Possibility of Paper Jam due to the failure of Tandem Paper Feed UNIT

Tandem Paper Feed for Phoenix

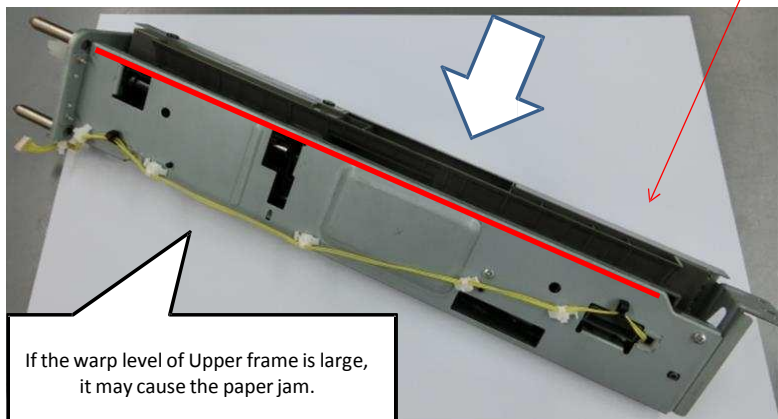
The overlapped area between the paper feed roller and separation roller becomes less due to the warp of the upper frame of Tandem paper feed, which may cause the center of the paper being bent or may cause the paper jam. (Tray3 or Tray4 Jam)

If the warp level of Upper frame is large, it may cause the paper jam.
